Global registry

Addendum 5: Global technical regulation No. 5

Technical requirements for on-board diagnostic systems (OBD) for road vehicles

Amendment 1

"Figure 4

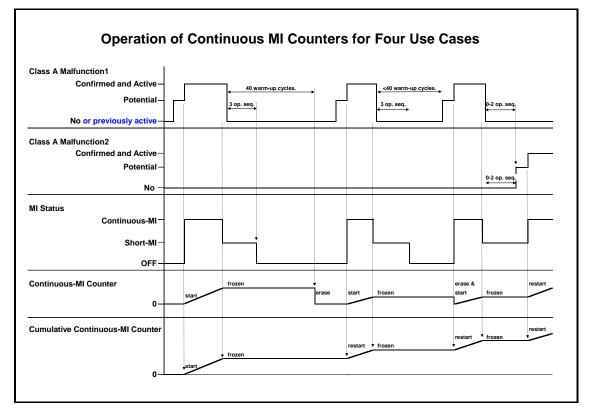
Figure 4, amend to read:

Class A malfunction -activation of the MI and MI counters

Note:

Details related to the deactivation of the continuous MI are illustrated in figure 4bis below in the specific case where a potential state is present."
